DESCRIPTIVE REPORT

Type of Survey Hydrographic
Field No. RA-10-23-99
Registry No. H-10933

State Alaska
General Locality Southwest Prince William Sound
Sublocality Snug Harbor and Vicinity

Descriptive Report to Accompany Hydrographic Survey H10933

AWOIS 52429 ✓

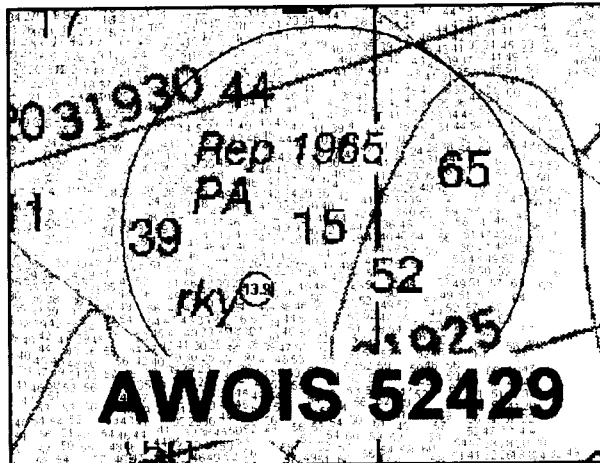
5. Results of Investigation: Soundings from 100% SWMB coverage indicate a 13.9-fathom shoal (Pos. #150805) at 60°15'49.69"N, 147°40'28.56"W. ✓

7. Comparison with the Chart and Charting Recommendation: Compared with chart 16700; 26th Ed.; Sept 19, 1998; 1:200,000. The chart shows a 15-fathom shoal charted as position-approximate, 300m ENE of the 13.9-fathom sounding. Compared with chart 16701; 17th Ed; July 25, 1998; 1:81,436. This chart also shows the position-approximate sounding 330m northeast of the 13.9-fathom shoal. The present survey found depths ranging from 29-34 fathoms over the charted 15 fms Rep 1965 PA.

The Hydrographer recommends removing the position-approximate sounding and replacing it with soundings from this survey. Concur Chart 14fm depth from the present survey.

AWOIS 52430 ✓

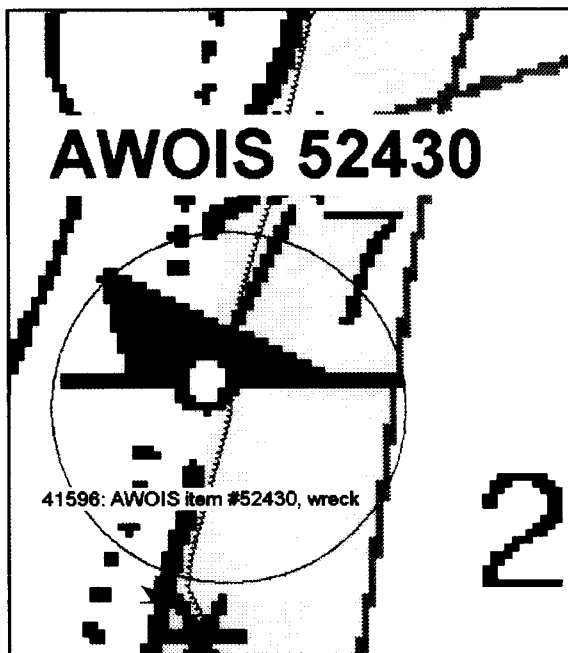
5. Results of Investigation: A visual search located the broken hull of a vessel atop a ledge 230m south of the charted location. There was no positive identification of the vessel name. The vessel poses no threat to navigation in its current location of 60°13'38.66"N, 147°42'24.12"W. ✓ *Concur*

7. Comparison with the Chart and Charting Recommendation: Compared with chart 16700; 26th Ed.; Sept 19, 1998; 1:200,000. The chart shows a wreck 230m north of the wreck's surveyed location. Compared with chart 16701; 17th Ed; July 25, 1998; 1:81,436. This chart also shows the wreck 230m north of its surveyed location. *Concur*

It is recommended that the position of the wreck be revised to 60°13'38.66"N, 147°42'24.12"W on all charts. *Concur Chart visible wreck as found on the present survey.*

AWOIS 52498 ✓

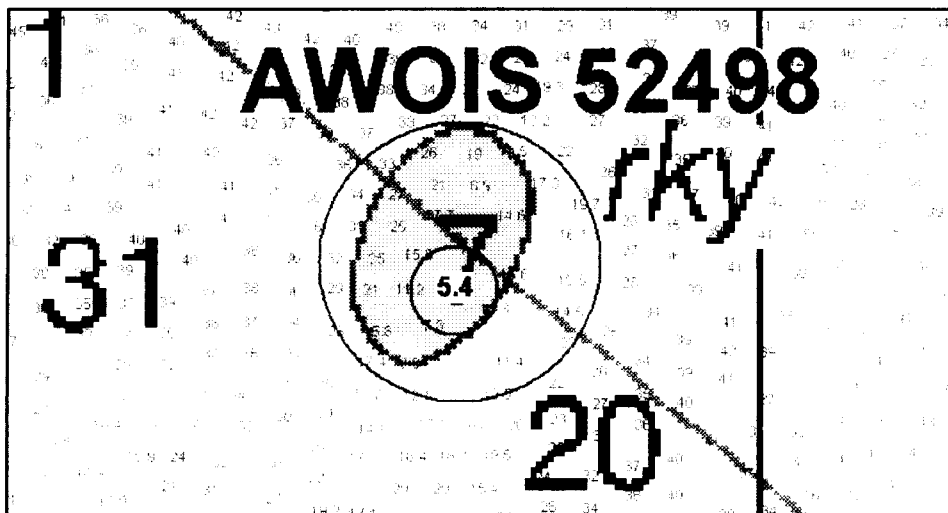
5. Results of Investigation: Soundings from 100% SWMB coverage revealed a 32-foot (5.4-fathom) shoal (Pos. #189076) in same vicinity as the 44-foot sounding on prior survey H-3026. *Concur*
Present survey found depths ranging from 5.4 - 8.8 Fathoms over the prior 7 Fathom.

7. Comparison with the Chart and Charting Recommendation: Compared with chart 16700; 26th Ed.; Sept 19, 1998; 1:200,000 and with chart 16701; 17th Ed; July 25, 1998; 1:81,436. Both charts show a 7-fathom shoal. *Concur*

The hydrographer recommends superseding the charted 7-fathom sounding with soundings from this survey. *Concur Chart 5.4 Fm depth from the present survey.*

AWOIS 52499 ✓

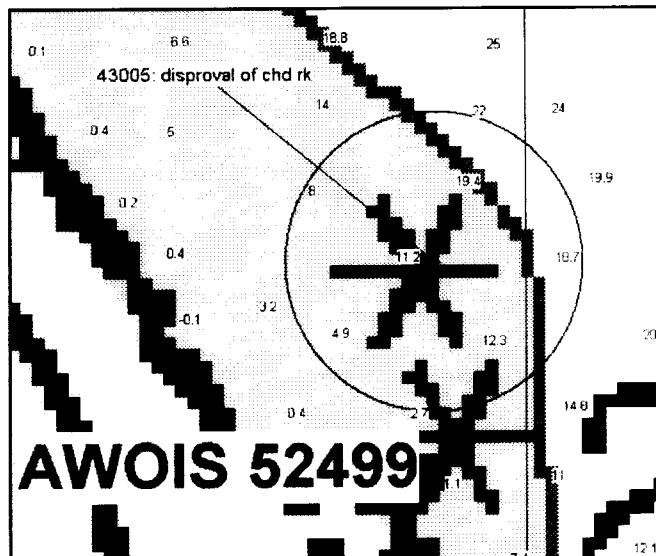
5. Results of Investigation: The rock awash was not located in the visual search. At the location of the reported rock awash a detached position (Pos. #43005) was taken with a sounding of 24.0 meters. *Concur. The present survey found depths ranging from 11.2-15.1 fathoms over the charted rock.*

7. Comparison with the Chart and Charting Recommendation: Compared with chart 16701; 17th Ed; July 25, 1998; 1:81,436. Two rocks are depicted 130 meters apart on this chart and near the location of the AWOIS item. The northern rock is the disproved AWOIS item and the southern rock is actually the high point of a ledge. The hydrographer recommends removing both rocks and replacing the southern rock with a ledge. Compared with chart 16700; 26th Ed.; Sept 19, 1998; 1:200,000. This chart depicts one rock which represents the two rocks on 16701. The Hydrographer recommends removing this rock and placing a ledge in its location. *Do not concur.*

Chart ledge as a rock based on present survey information. Delete charted AWOIS item 52499 (rock) as recommended by the hydrographer.
